IN THE DRAWINGS:

Fig. 48

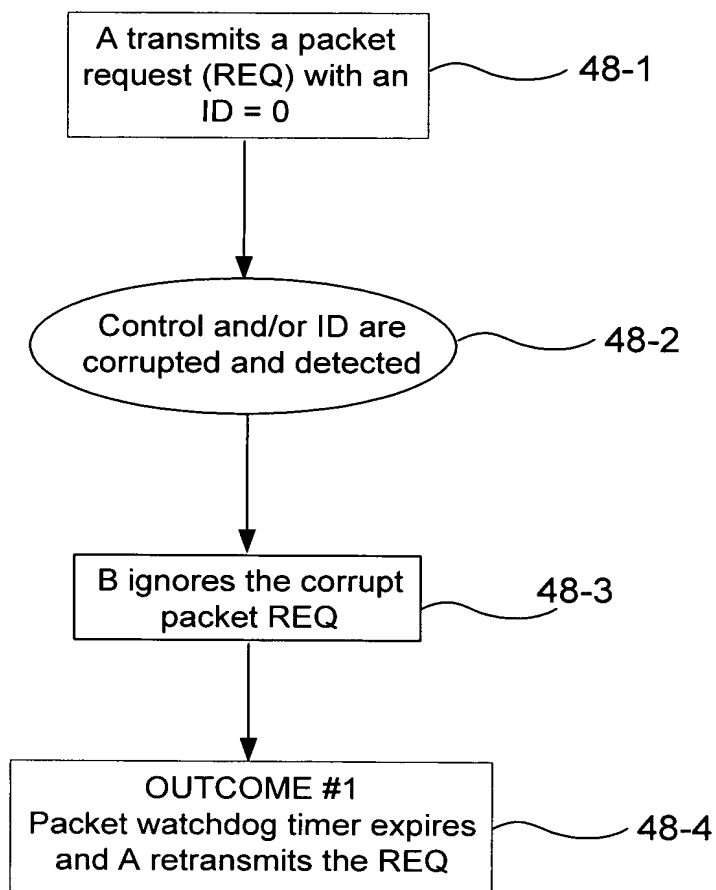
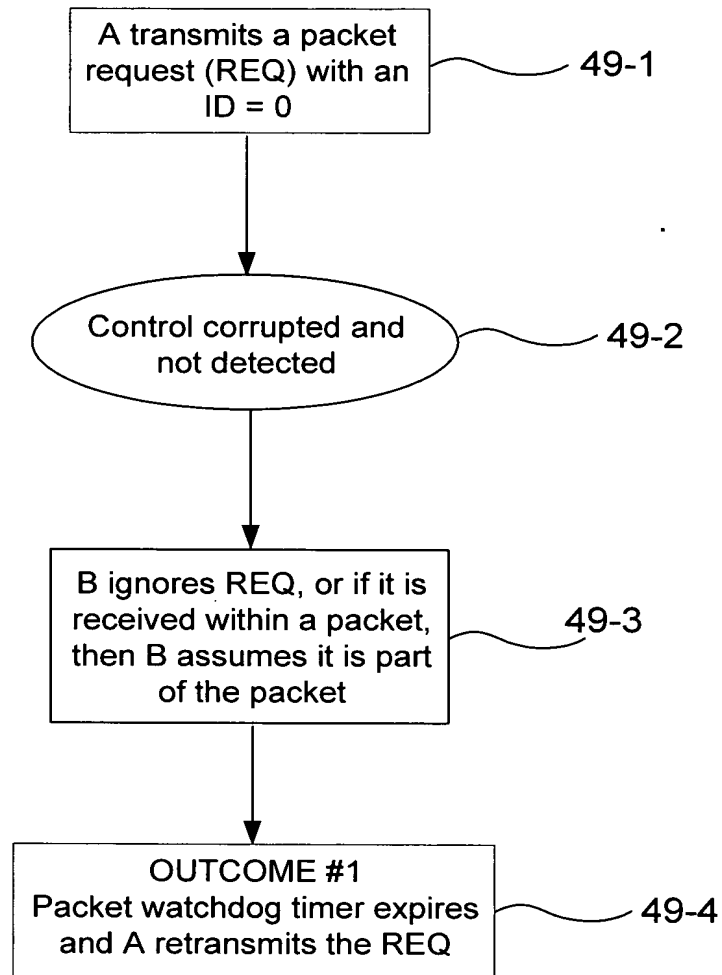
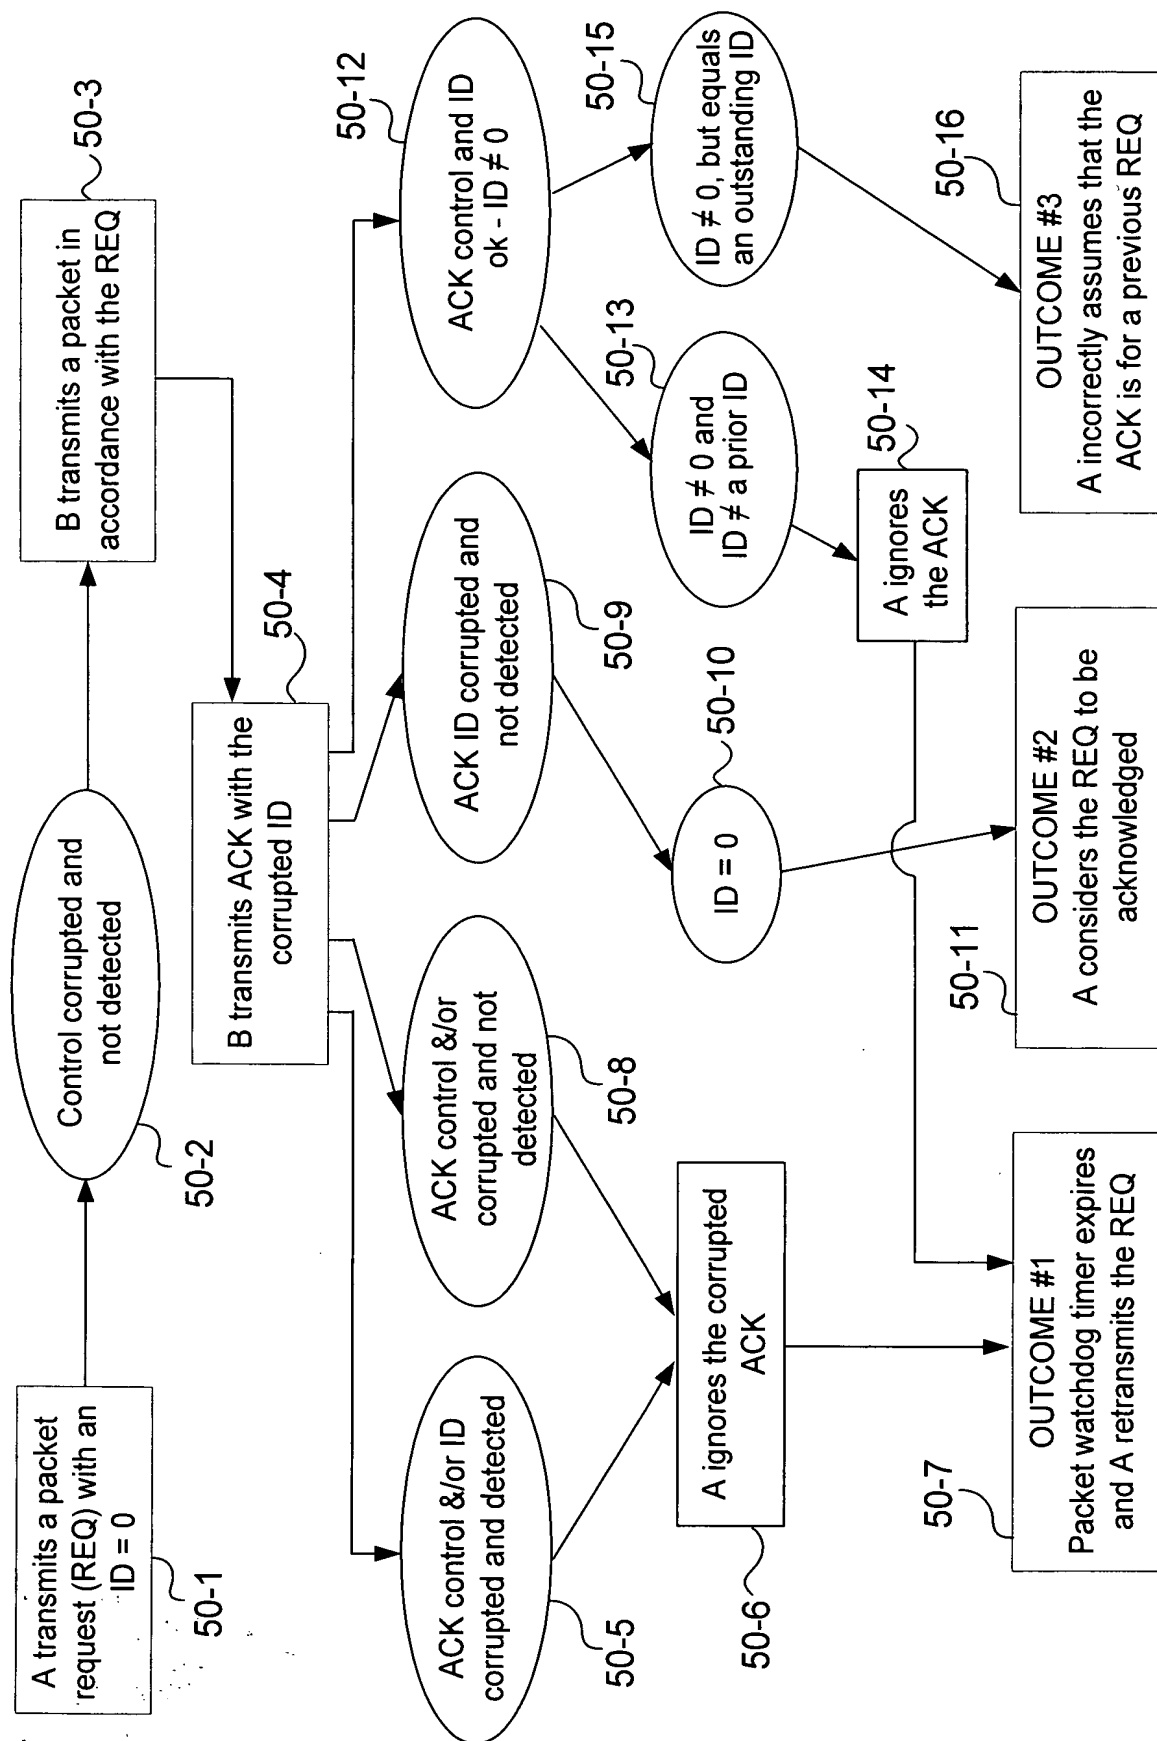
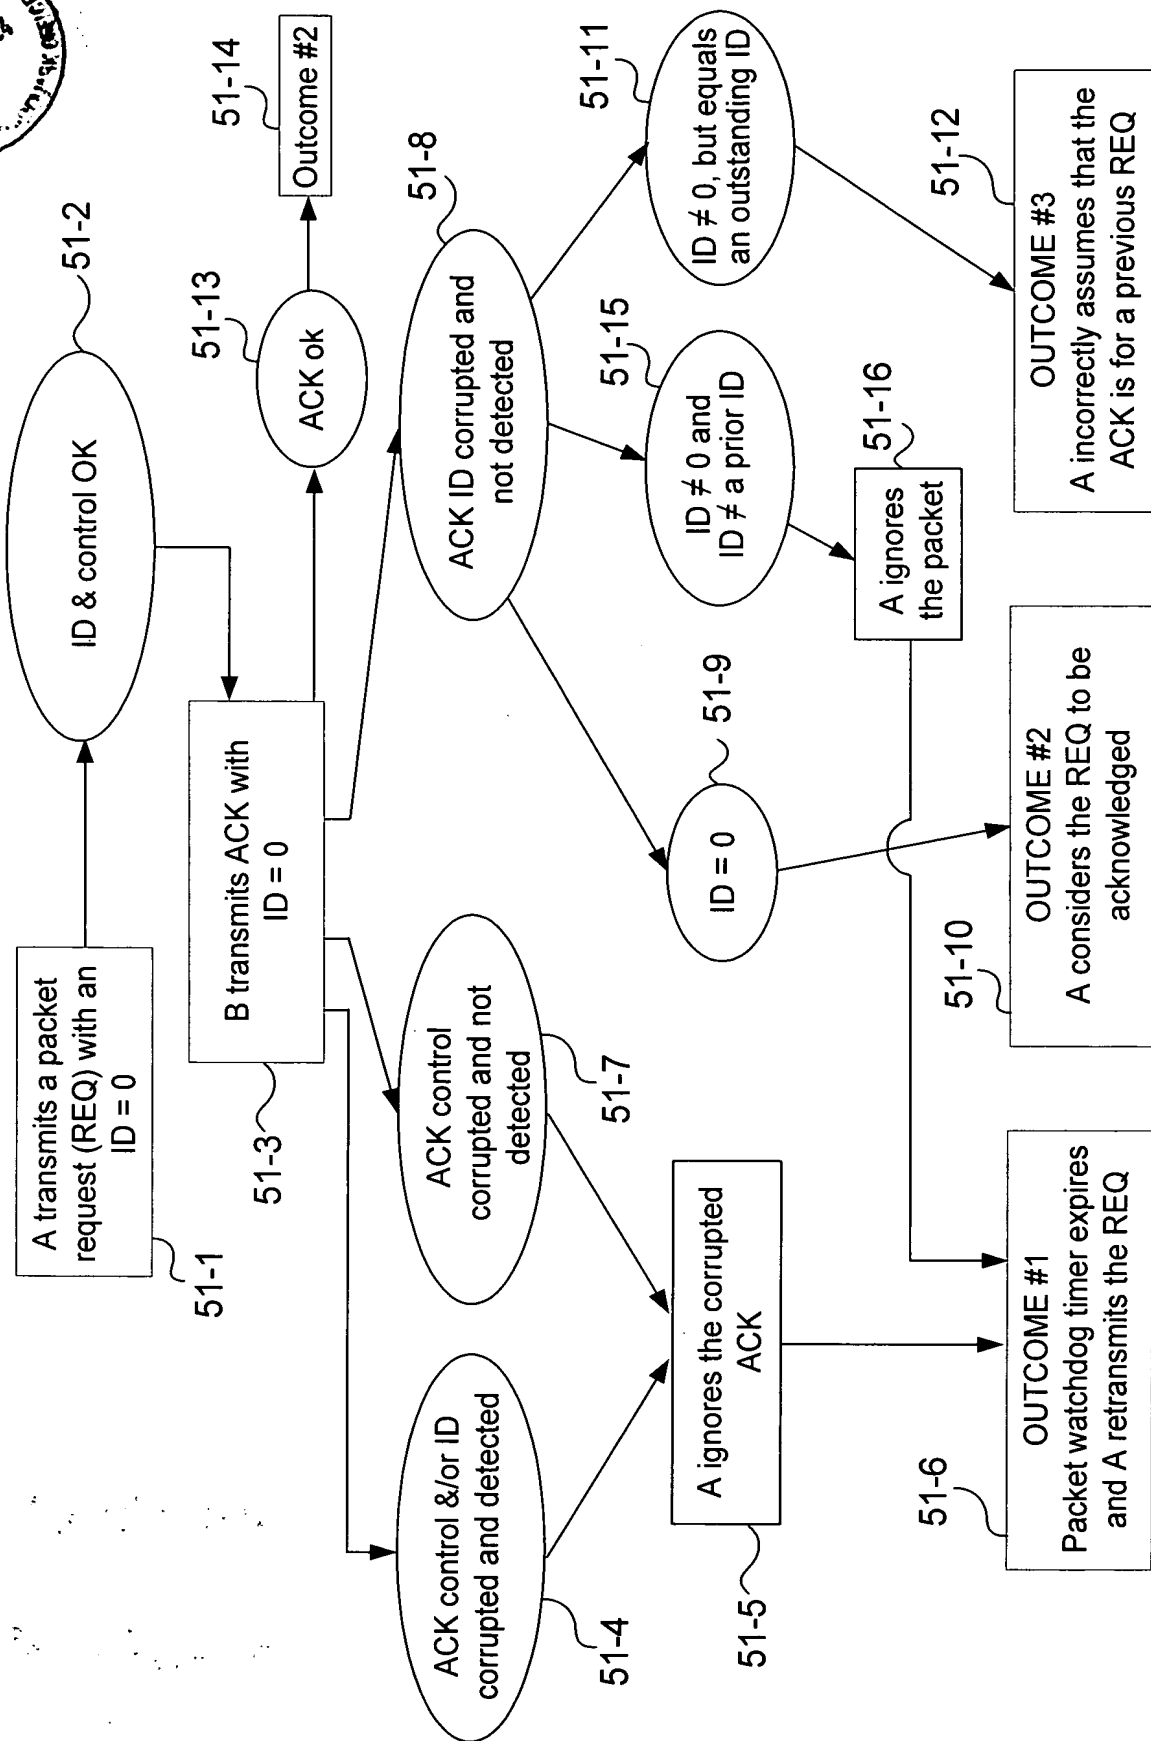
Please replace the original sheets containing Figs. 48-51 with the attached replacement sheet containing Figs. 48-51. The labeling was indicated as being handwritten and formal correction was requested by the Examiner.
